CONTRACT NO. DE-AC06-96RL13200 – REPORT ON THE DEFENSE NUCLEAR FACILITIES SAFETY BOARD (DNFSB) RECOMMENDATION 2000-2 PHASE II ASSESSMENT OF THE FIRE PROTECTION SYSTEMS AT THE CENTRAL WASTE COMPLEX (CWC)

**Report on the
DNFSB Recommendation
2000-2 Phase II Assessment
of the Fire Protection Systems at the
Central Waste Complex**

ESD-PH2-CWC-02-001

Figure 1: CWC Building 2402WF Water Supply and Sprinkler Demand Curve

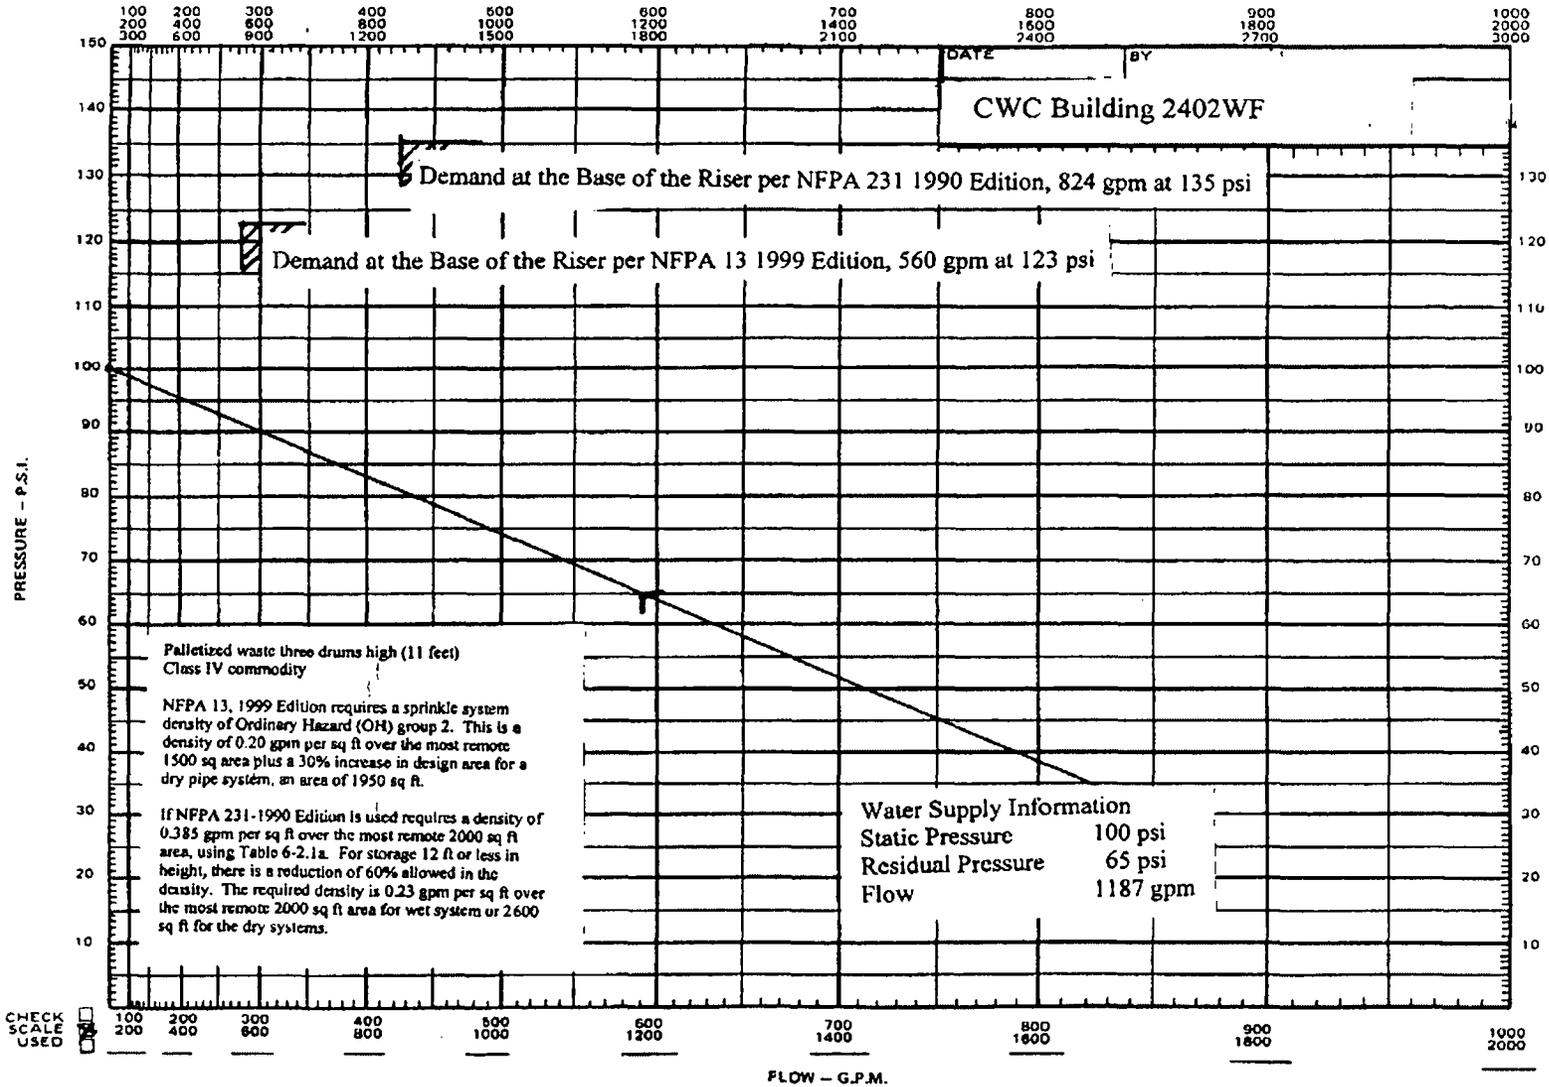
The water supply cannot provide the required flows. The water supply has a static pressure of 100 psi with a residual pressure of 65 psi at a flow of 1187 gpm based HFD test done January 25, 2002. See Figure 1.

The sprinkler systems as installed can only provide about half of the required sprinkler system density. With this reduced density, a fire starting in the palletized storage may not be controlled. This could lead to failure of the building steel and the building could fall to the ground. The fire could continue to burn in an uncontrolled manner.
